Access Compliance Report

Public Rights-of-Way

(Curb Ramps)

Intersection ID: 10038956	Main Street: STONEMEDE_LN	Cross Street: N/A	Location: E
ADA ID: C4CA3235F6AE	Ramp Type: Perp	Initial Pass/Fail: Pass	Overall Compliance: No
			Severity Score: 7.75
Codes/Mitigation Info/Possible Solution		Field Measurements/Component Compliance

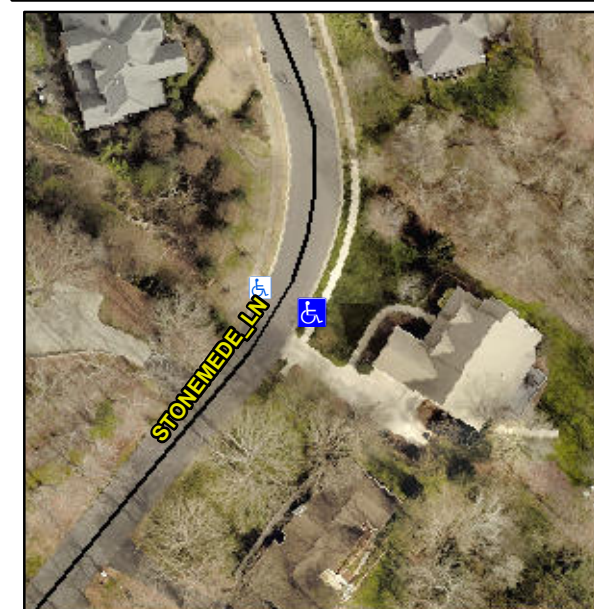
**Not Found, R304.2.3, R304.5.4,
R304.5.3**

Compliance	Description	Data	Compliance	Description	Data
N/A	Ramp Length (in)	47.5	Yes	Ramp Slope (%)	7.3
Yes	Ramp Width (in)	48.0	Yes	Ramp XSlope (%)	4.1
N/A	Flare Type LT	Sloped	N/A	Flare Type RT	N/A
N/A	Flare Slope LT (%)	4.8	No	Flare Slope RT (%)	11.8
N/A	Flare Traversable LT?	Yes	N/A	Flare Traversable RT?	Yes
Yes	Landing Length (in)	48.0	Yes	DWS Provided?	Yes
Yes	Landing Width (in)	48.0	Yes	DWS Contrast?	Yes
Yes	Landing Slope (%)	1.1	Yes	DWS Length (in)	24.0
Yes	Landing X Slope (%)	4.4	Yes	DWS Full Width?	Yes
N/A	Landing Curb? (Y/N)	No	Yes	DWS Offset (in)	0.0
N/A	Shared Landing?	No			
Yes	Gutter Ponding?	No	No	Gutter Slope (%)	6.4
Yes	Gutter Lip Ht (in)	0.0	No	Gutter X Slope (%)	5.4
N/A	Painted X Walk1?	No	N/A	Painted X Walk2?	N/A
	X Walk 1 Direction	To NW		X Walk 2 Direction	N/A
N/A	X Walk 1 Width (in)	N/A	N/A	X Walk 2 Width (in)	N/A
	X Walk 1 Slope (%)	3.5		X Walk 2 Slope (%)	N/A
	X Walk 1 X Slope (%)	4.5		X Walk 2 X Slope (%)	N/A

N/A	Ramp inside XWalk1?	N/A	N/A	Ramp inside XWalk2?	N/A
	Road Slope (%)	N/A	N/A	Clear Space?	Yes
	Road X Slope (%)	N/A	N/A	Clear Space to XWalk (in)	N/A
Yes	Any Obstructions?	No	Yes	Storm Grate/Utility Hazard?	No
	Obstruction Type			Storm Grate/Utility Type	
		N/A			N/A
			Yes	Surface Condition? (G/P)	Good

**Remove & Replace Entire Ramp.
Remove & Replace Gutter.**
